Access Compliance Report

Public Rights-of-Way

(Curb Ramps)

Intersection ID: 2698	Main Street: GRABURN'S_FORD_DR	Cross Street: HIGHLAND_CREEK_PY	Location: SW
ADA ID: E0BA69FE3B92	Ramp Type: Perp	Initial Pass/Fail: Fail	Overall Compliance: No
Severity Score: 60			
Codes/Mitigation Info/Possible Solution		Field Measurements/Component Compliance

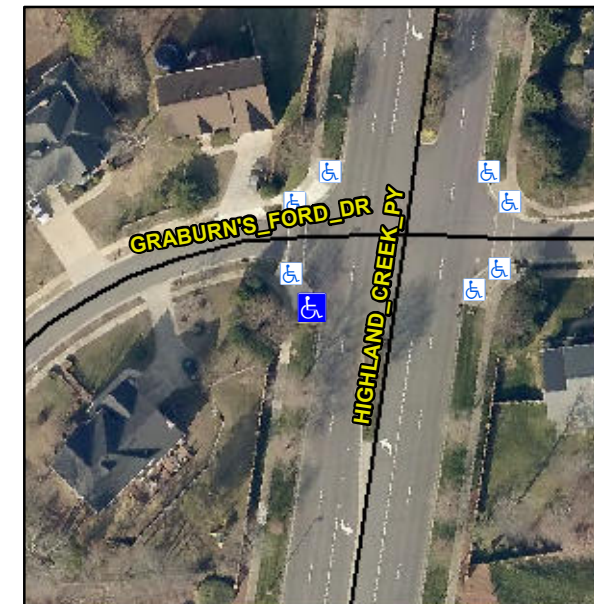
Not Found, R304.5.1, R304.2.2

Compliance	Description	Data	Compliance	Description	Data
N/A	Ramp Length (in)	144.0	No	Ramp Slope (%)	12.5
No	Ramp Width (in)	31.5	Yes	Ramp XSlope (%)	0.8
N/A	Flare Type LT	N/A	N/A	Flare Type RT	N/A
N/A	Flare Slope LT (%)	N/A	N/A	Flare Slope RT (%)	N/A
N/A	Flare Traversable LT?	N/A	N/A	Flare Traversable RT?	N/A
N/A	Landing Length (in)	N/A	N/A	DWS Provided?	N/A
N/A	Landing Width (in)	N/A	N/A	DWS Contrast?	N/A
N/A	Landing Slope (%)	N/A	N/A	DWS Length (in)	N/A
N/A	Landing X Slope (%)	N/A	N/A	DWS Full Width?	N/A
N/A	Landing Curb? (Y/N)	N/A	N/A	DWS Offset (in)	N/A
N/A	Shared Landing?	N/A			
N/A	Gutter Ponding?	N/A	N/A	Gutter Slope (%)	N/A
N/A	Gutter Lip Ht (in)	N/A	N/A	Gutter X Slope (%)	N/A
N/A	Painted X Walk1?	No	N/A	Painted X Walk2?	N/A
	X Walk 1 Direction	To E		X Walk 2 Direction	N/A
N/A	X Walk 1 Width (in)	N/A	N/A	X Walk 2 Width (in)	N/A
	X Walk 1 Slope (%)	2.1		X Walk 2 Slope (%)	N/A
	X Walk 1 X Slope (%)	8.8		X Walk 2 X Slope (%)	N/A

Remove & Replace Entire Ramp.
